ADDENDUM

Project Name: Utility Tunnel Extension
DFCM Project #04245730
Project Designation: SUU University Cedar City, Utah

Addendum No.: One (1)

Date: April 15, 2005

EXISTING MANHOLE PLAN & NEW TUNNEL CONNECTION

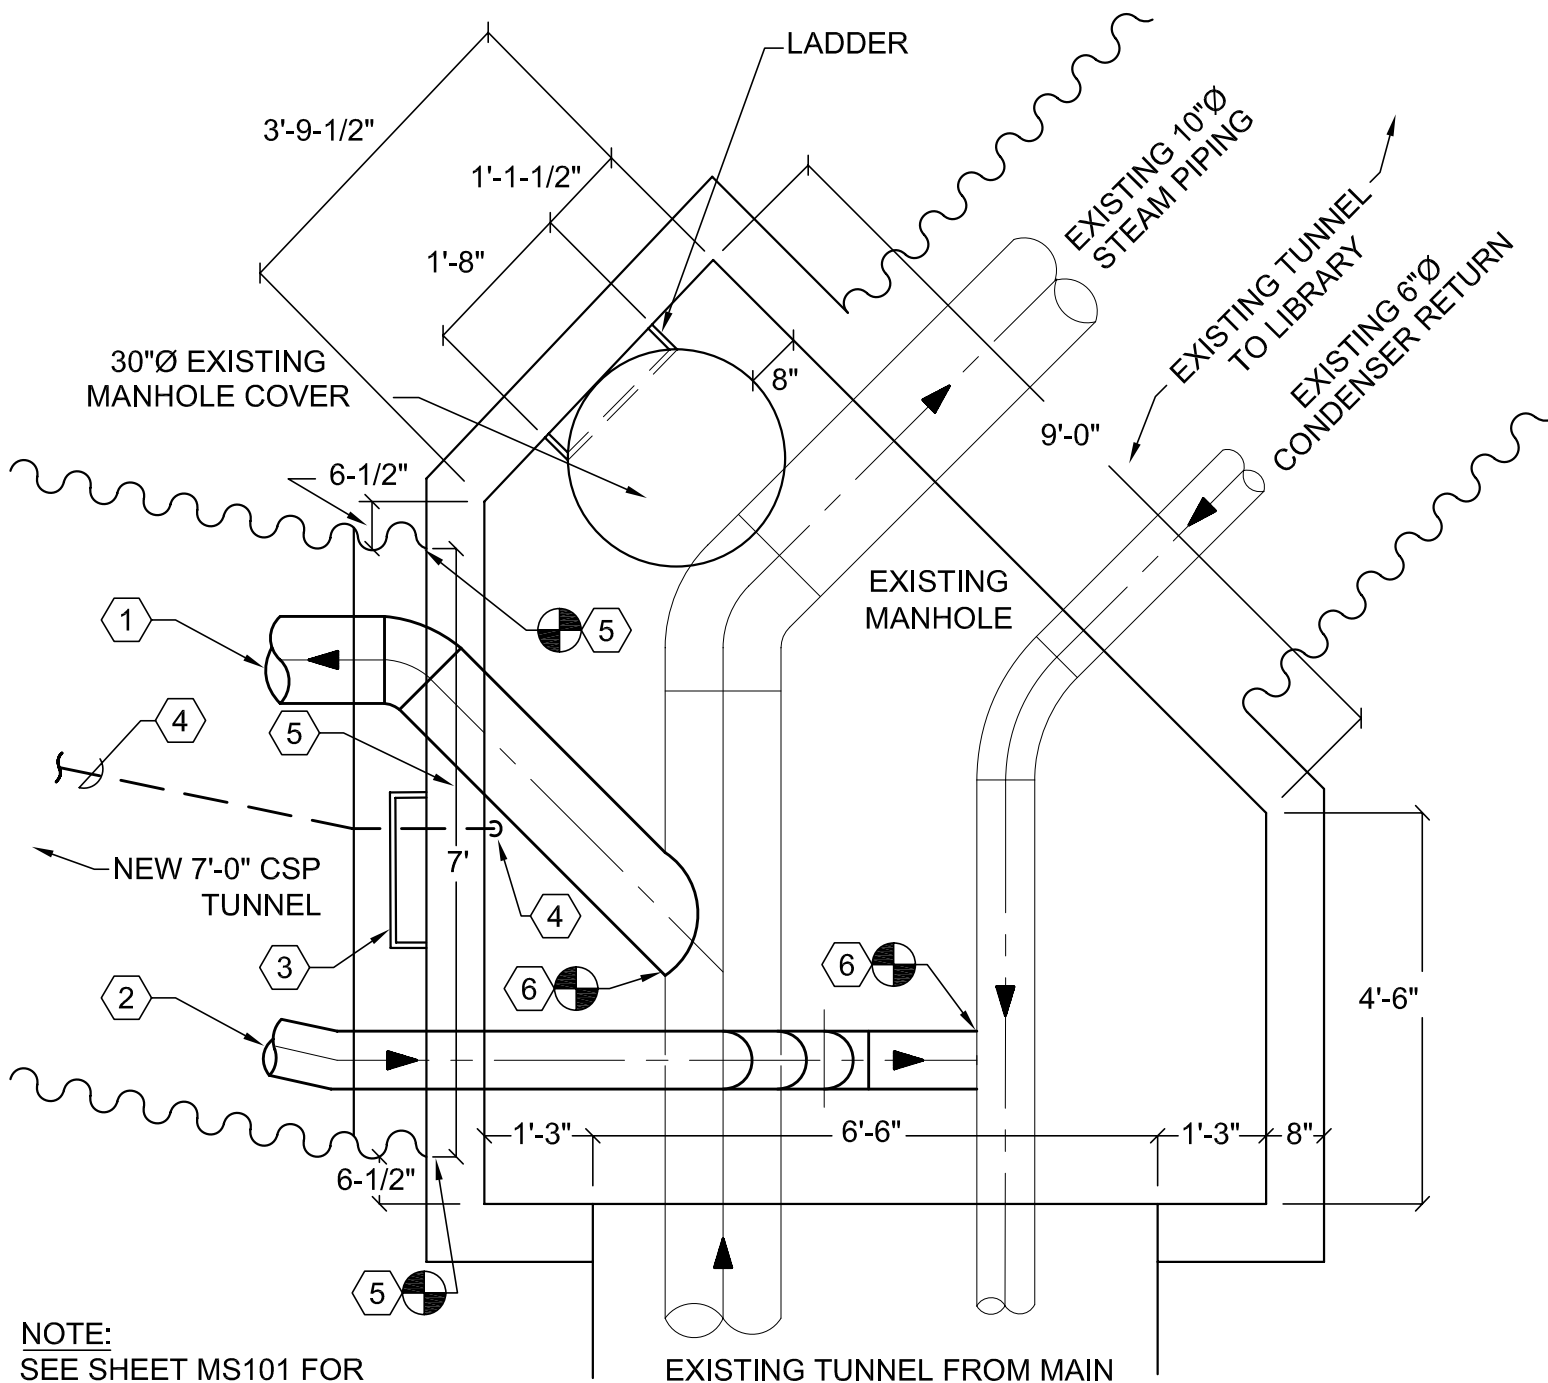
Item VI-15. Drawing ME502 detail C5 see attached drawing C5/ME502 for clarification.

- 1 NEW 6" STEAM SUPPLY
- 2 NEW 4" CONDENSATE RETURN
- 3 NEW LADDER SEE DETAIL C3/ME504
- 4 1"Ø PVC DRAIN LINE IN BOTTOM OF TUNNEL, DROP DOWN WALL TO EXISTING DRAIN.
- 5 SAW CUT EXISTING MANHOLE #1 WALL AND REMOVE FOR NEW TUNNEL. SEE ATTACHED DRAWING C3/ME502.
- 6 NEW PIPING CONNECTIONS.

C5 PIPING ELEVATION MANHOLE #6

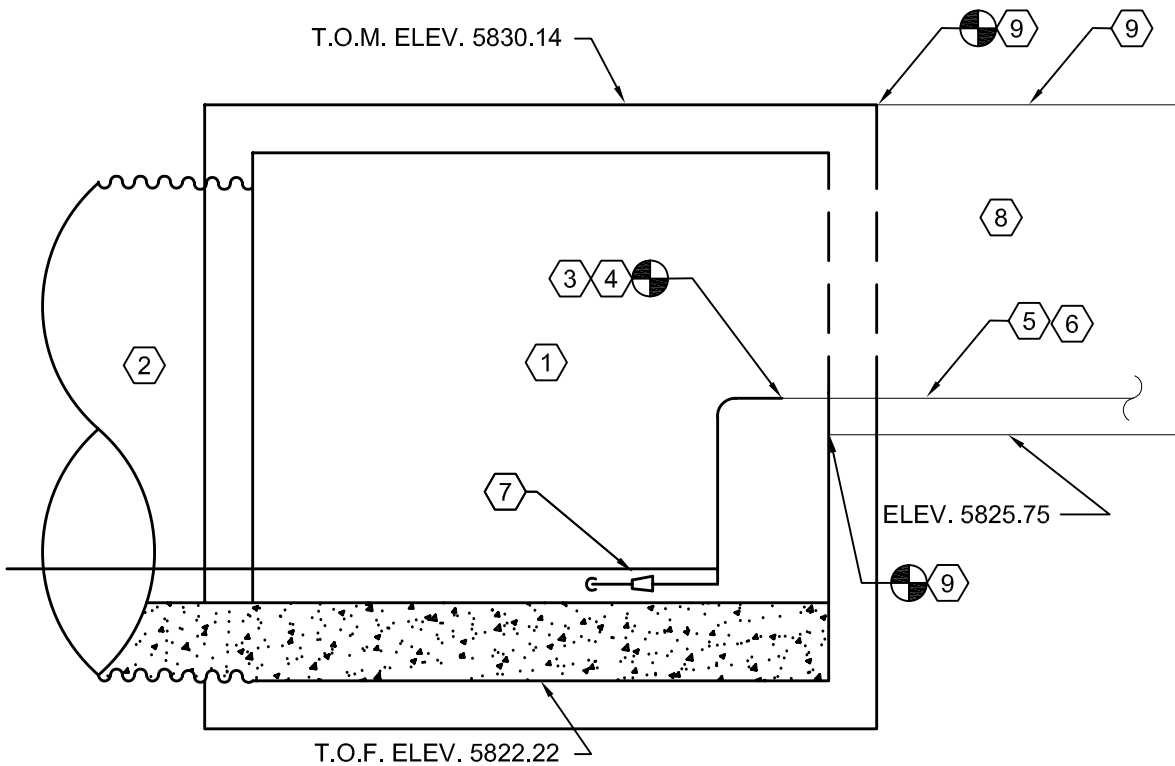
MANHOLE #6: This is a **new** 8' x 8' concrete manhole. See detail C5/ME503 and profile sheet CS102 for depth. All piping between MH #5 and MH #6 is **new**. Connections between new tunnel and piping and existing Music Building tunnel and piping takes place at this manhole. See B5/ME101 for details. See attached drawing.

Item VI-12. Drawing MS101 - note 10 refers to existing building pipe tunnels that remain and shall connect to **new** manholes #4 and #6. Existing pipe tunnel connection to manhole #4 requires modifications. See attached drawings C5/ME503.

- ① MANHOLE #6 - 8'-0" x 8'-0".
- ② NEW 7'-0" CSP TUNNEL.
- ③ NEW 3" STEAM SUPPLY PIPING.
- ④ NEW 1-1/2" CONDENSATE RETURN PIPING.
- ⑤ EXISTING 3" STEAM PIPING.
- ⑥ EXISTING 1-1/2" CONDENSATE RETURN PIPING.
- ⑦ STEAM TRAP, SEE DETAIL A4/ME504.
- ⑧ EXISTING TUNNEL FROM ELC. BLDG.
- ⑨ CONNECT EXISTING TUNNEL INTO NEW MANHOLE #6.

TUNNEL SECTION FILL REQUIREMENTS

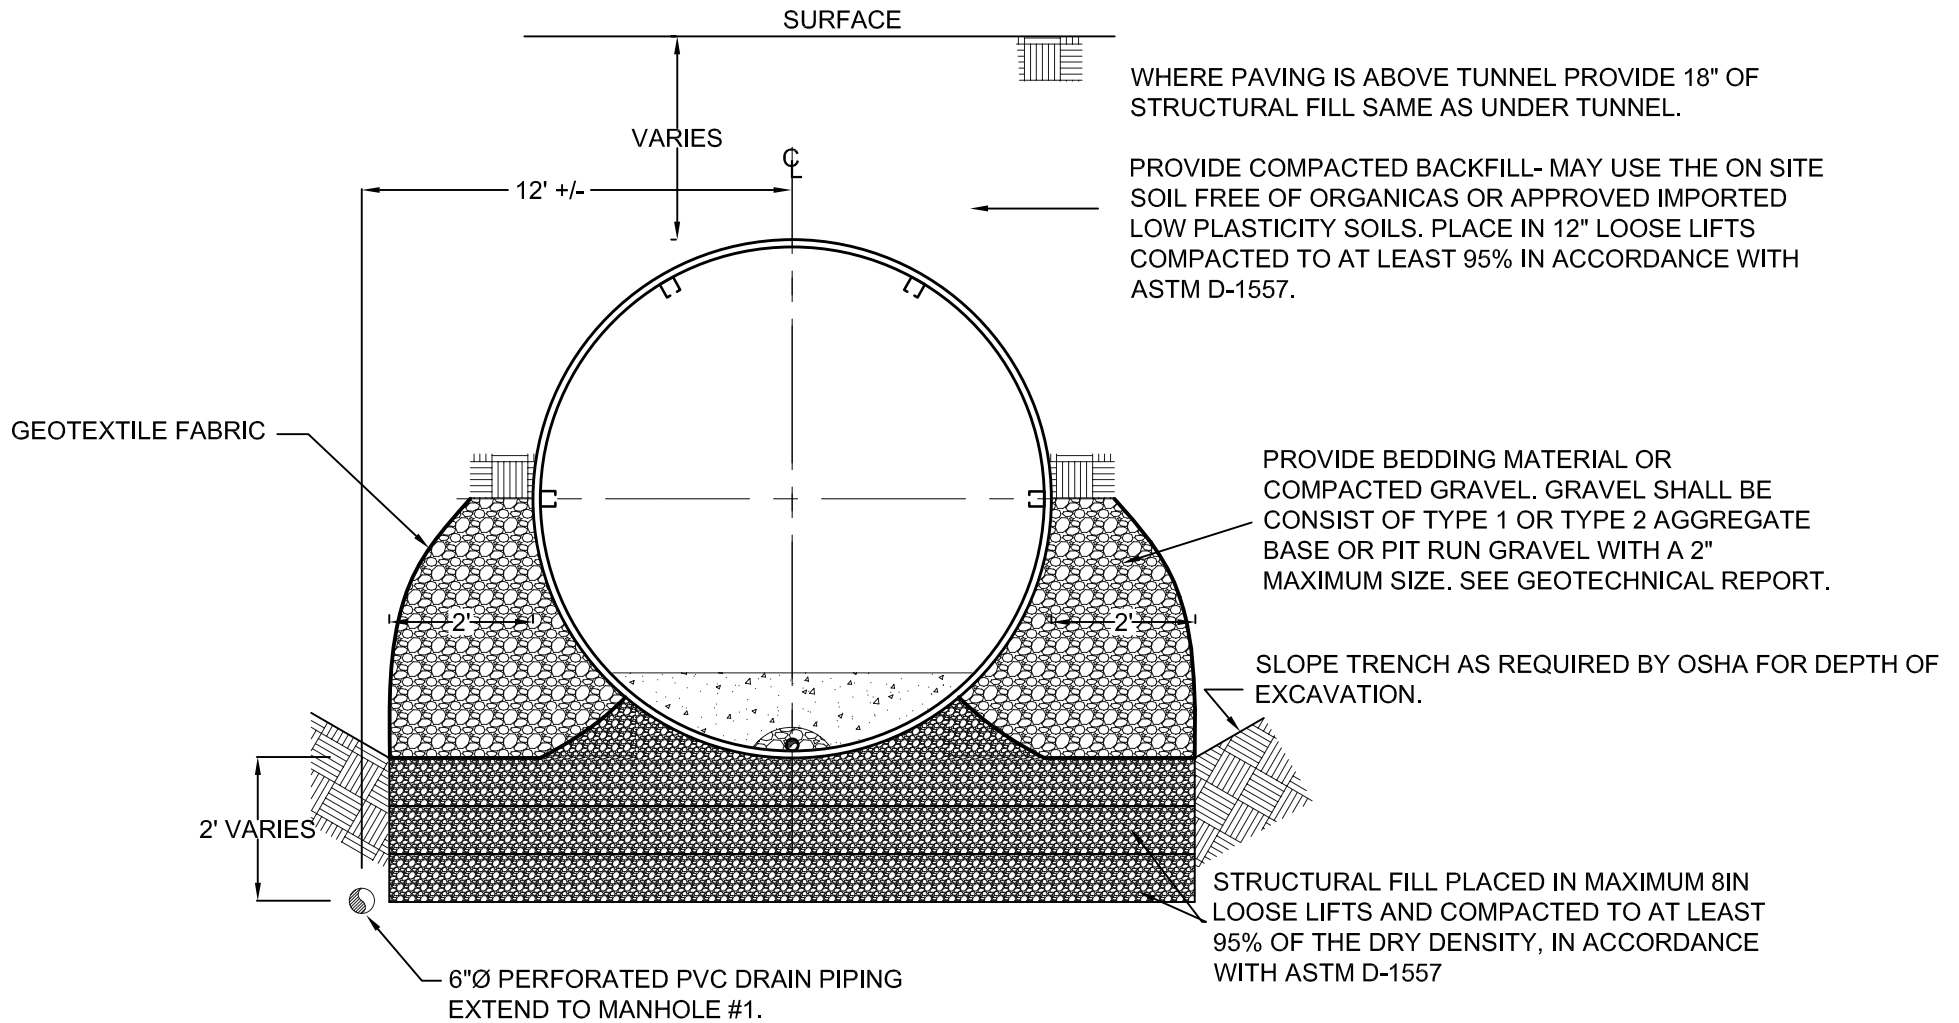
Item VI-17. Drawing ME 503 detail section D1 is a typical section for the backfill. The 2'-0" structural fill under the tunnel is typical throughout.

- Item VI-24.** Detail D1/ME503 add geotextile fabric between the gravel and the structural fill to keep the gravel from embedding in the fill. Provide a 6" diam. PVC perforated pipe below tunnels and a minimum of 12' -0" away from centerline of tunnel. See attached drawing D1/ME503.

MANHOLE ELEVATION DETAIL

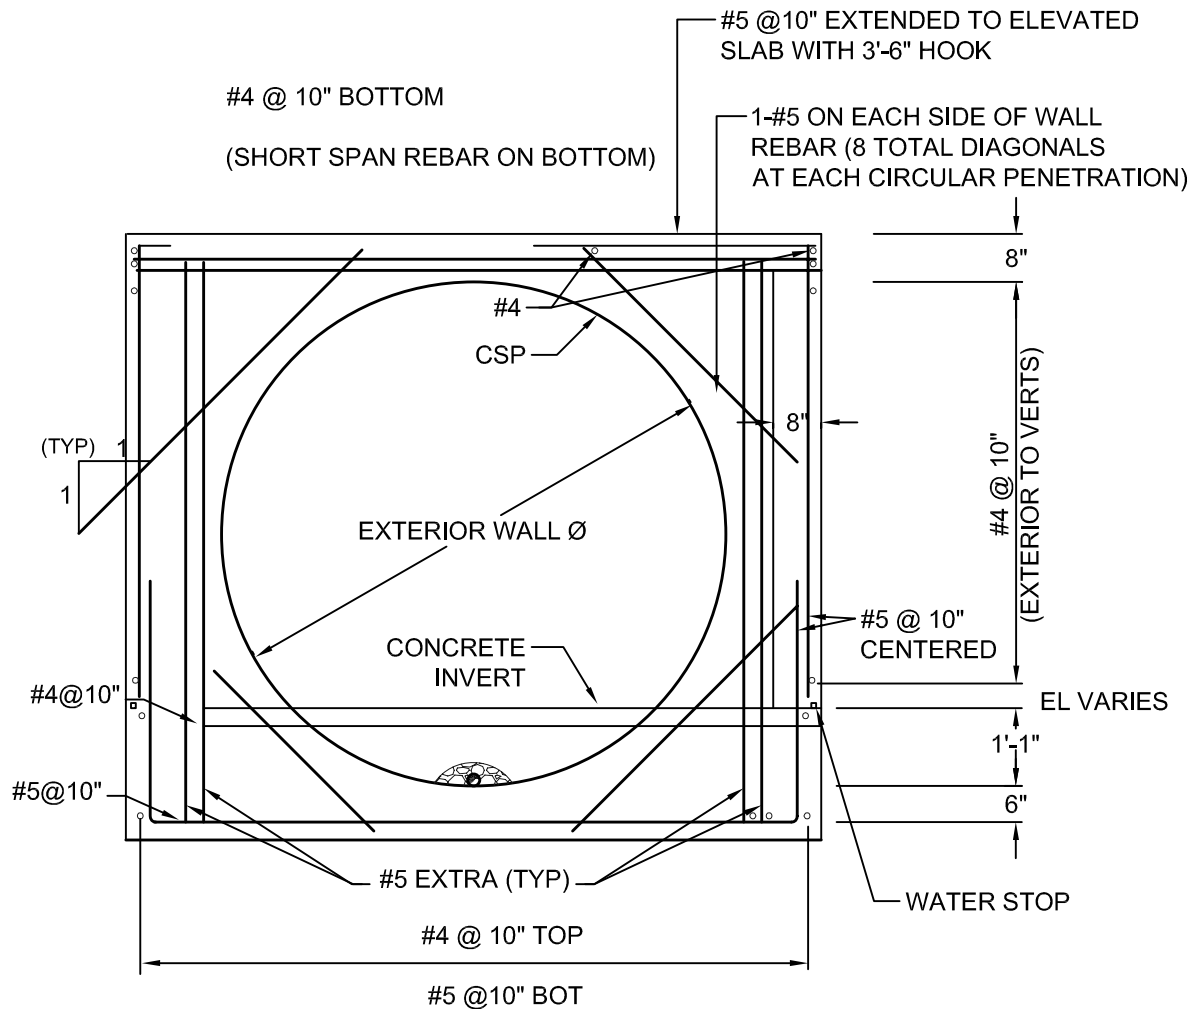
- Item VI-20.** Drawing ME504 details C1 and D5 apply to tunnel to manhole connections - typical. See attached drawings C1/ME504 and D5/ME504.
- Item VI-21.** Drawing ME504 see attached drawings for update of existing details A2, A5, C1, D1 and D5.

- ① TYPICAL ELEVATION OF TUNNEL PENETRATION INTO MANHOLES.
